Errata for '02 VDOT DRAINAGE MANUAL

Note: The errata information shown below will be incorporated into the text of the manual the next time it is revised.

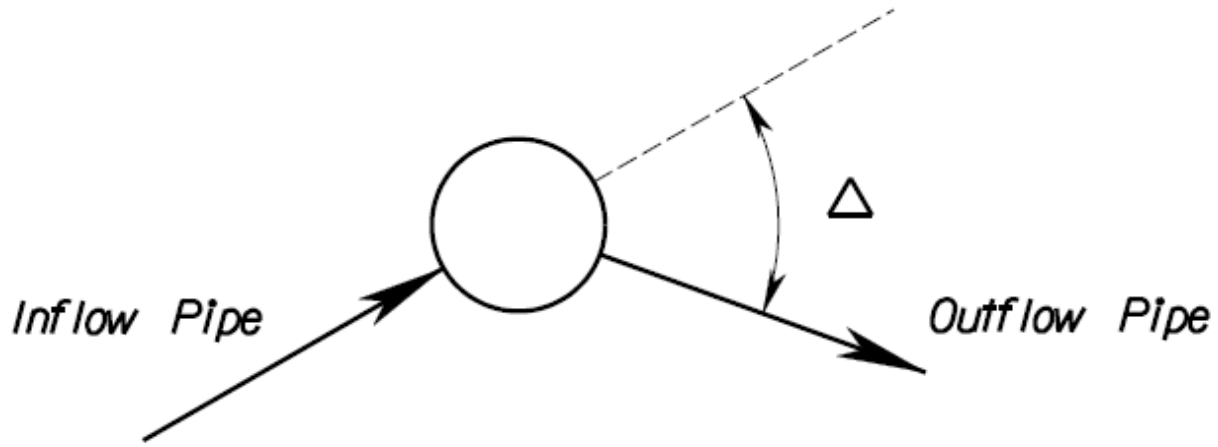
Chapter 9, Section 9.4.9.3.2.3 (Bend Losses), Figure 9-9: The current drawing should be replaced with that shown below and the description should be changed to read **Deflection** Angle between Inflow and Outflow Pipes.
